HORSHAM DISTRICT COUNCIL CONSULTATION

TO:	Horsham District Council – Planning Dept
LOCATION:	Land at Lower Broadbridge Farm Billingshurst Road Broadbridge Heath Horsham
DESCRIPTION:	Reserved matters application for the erection of 133 dwellings following approval of outline application DC/22/1052 as amended by DC/25/1886, relating to appearance, landscaping, layout and scale
REFERENCE:	DC/26/0592
RE-CONSULT:	1 st set of comments in black 2nd set of comments in blue
RECOMMENDATION:	More Information / Modification More Information / Modification

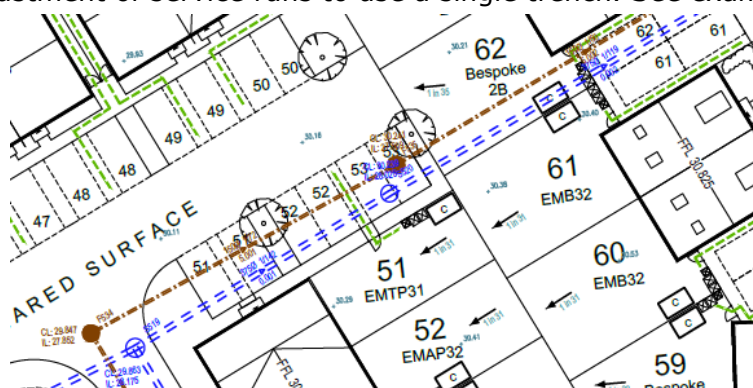
11. A plan demonstrating coordination of the landscape strategy with underground services and existing easement zones is required at this stage to ensure that it can be delivered and that it is not diluted later on in the process.

Not yet addressed; to be secured via condition.

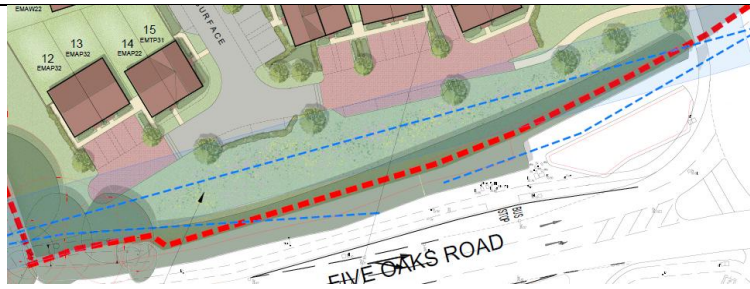
- a. The adjustment of service runs to use a single trench. See example below.

- b. Trees within and adjacent to hard landscape to be inclusive of root cells. Details to be included within the Planting Specification and Tree Pit Details.

Not yet addressed; to be secured via condition.

Not yet addressed. Please provide an updated Planting Specification and Tree Pit Details, or justification for not proposing root cells. This can alternatively be secured via condition.

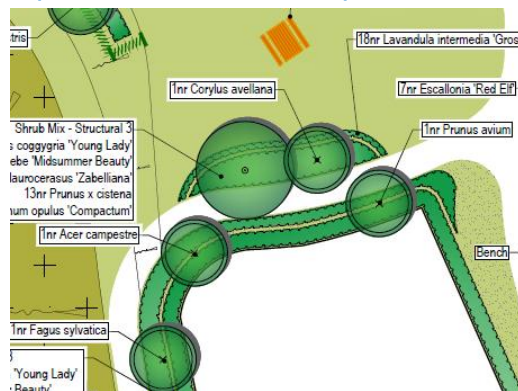
14. The Landscape Strategy has been significantly diluted, therefore major modification is required in order to deliver closer to previously submitted under DC/22/1052. Of key concern is the large reduction of proposed trees; there are currently only 173 proposed compared to 322 within the Landscape Strategy under DC/22/1052. This is most acute in open spaces, for example, the open space to the north only has 37 proposed trees compared to 100 previously indicated. Please amend.

263 trees are now proposed. This figure remains considerably less than the 322 originally proposed under DC/22/1052, however the increase is welcomed. It is noted, however, that not all trees have labels; see below for an example. Please amend the planting schedule and plans to ensure consistency. This can alternatively be secured via condition.

[LEFT] DC/22/1052 Landscape Strategy, [RIGHT] current proposals

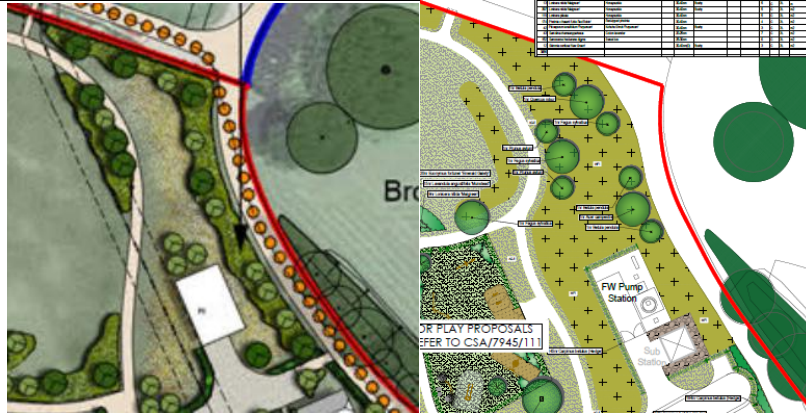
19. The Landscape Strategy under DC/22/1052 incorporated shrub planting and marginal planting within attenuation basins, detailing wetland meadow in combination with marginal species as well as Dogwood (*Cornus sanguinea*), coppiced Willow (*Salix* spp), Alder (*Alnus glutinosa*), Downy Birch (*Betula pubescens*). Current proposals solely indicate meadow mixture, which is not supported. Please amend, noting that some marginal species proposed under DC/22/1052 require permanent levels of water, therefore this must also be detailed in proposals.

Some amendments are noted, with thanks. Nonetheless, further marginal planting is recommended, particularly within the northern basin, and the species highlighted above continue to be requested in proximity to the basins. Further, *Caltha palustris* is proposed in areas that are intended to be dry. This species requires permanent levels of water and thus should be located where this can be ensured and/or replaced with alternative flowering species. Further amendments are thus required, although these can be secured by condition if preferred.

[LEFT] DC/22/1052 Landscape Strategy, [RIGHT] current proposals

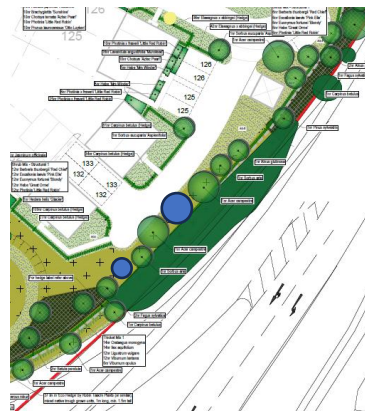
20. The Landscape Strategy under DC/22/1052 incorporated extensive structural native planting to reinforce the boundaries, provide a green setting to the development and add to the localised green infrastructure. This is absent from current proposals; see example below of only 6no. trees being proposed along the northeastern boundary. Please amend.

Amended, with many thanks. Closed.

GARDEN SEPARATION FENCING -

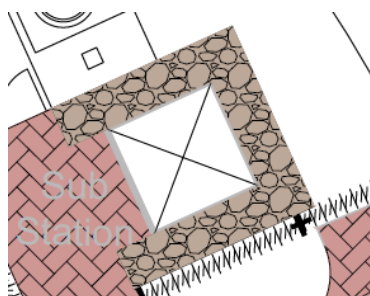
- b. What is garden separation fencing?

Updated to reflect '*1.8m timber larch lap panels, between timber posts, treated softwood*', with thanks. Closed.

[LEFT] DC/22/1052 layout, [MIDDLE] current masterplan, [RIGHT] current masterplan rev. A

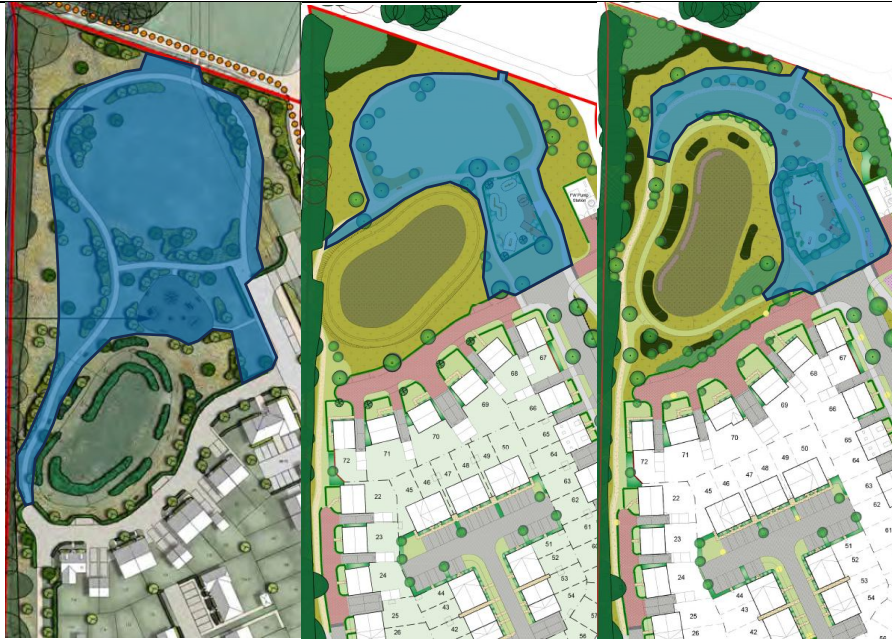
33. While the generous provision of Natural and Semi-Natural (NSN) space is noted, it is regrettable that the provision of open space has reduced in size since that submitted at outline stage. Constraints are noted, however given this reduction in quantity in combination with the non-usable areas allocated to attenuation basins, improvements must be made to proposals in order to deliver a high-quality scheme that aligns with the requirements of the OSSR and complies with HDPF policies 32 and 43.

- a. It is regrettable that usable informal recreation space has been reduced even further than previously submitted (see blue highlighted areas below, capturing amenity grass areas outside of SuDS). It is assumed that the attenuation basin has been enlarged to meet drainage requirements and to assimilate more naturally within the receiving landscape. However, amendments must be made to enhance and increase amenity greenspace in order to provide informal recreation pursuits such as 'kickabout' football, picnicking, kite flying and dog walking, as per the OSSR. Please consider relocating the treed footpath along the perimeter of this area and the picnic tables closer to the footpath in order to better allow for the informal activities listed above.

- b. The amendments to typology allocations are noted; while these continue not to accurately reflect descriptions, they are sufficient for the purposes of ensuring the OSSR requirements are met. Further, while increased seating provision continues to be recommended, the addition of a pergola and ornamental planting is welcomed. Closed.
